NUMBER: 08-022-07

Intermittent Illumination Of The Courtesy Lamps And Liftgate Ajar Indicator With Chime Tone

This bulletin involves switching the wires in the liftgate ajar switch connector.

Fig 74 LIFTGATE

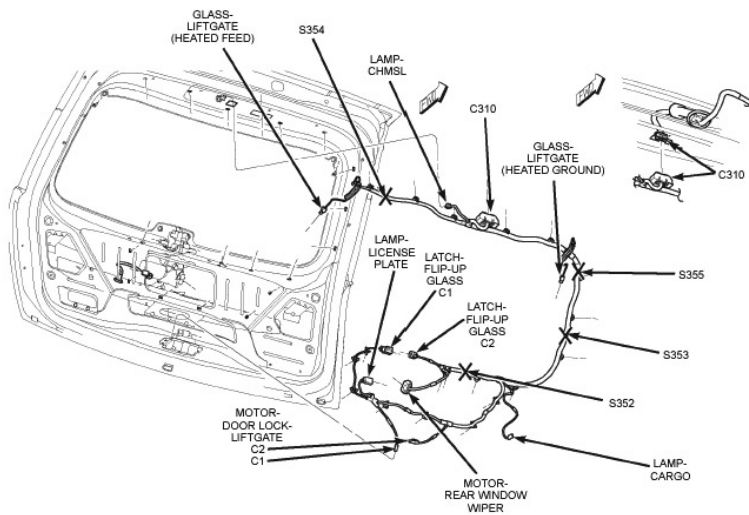
Customers may observe illumination of the courtesy lamps, a chime tone and the liftgate ajar indicator message illumination when the liftgate is not open. This is caused by intermittent contact of the liftgate open sensing wire closing the circuit to ground. Swapping the wires will make the intermittent contact with the body on the ground side wire, eliminating the false illumination and indicator messages.

3. Measure the voltage at cavity 1 of the 2-way liftgate ajar switch connector.
4. Is the voltage above 10 volts?
 - a. Yes >>> Further diagnosis is required, this service bulletin does not apply.
 - b. No >>> Proceed to [Step #5](#)
5. Turn ignition key off.
6. Swap wires in the 2-way liftgate ajar switch connector. Cavity 1 should contain the "G78 - liftgate ajar switch sense circuit" and cavity 2 should contain the "Ground" circuit.
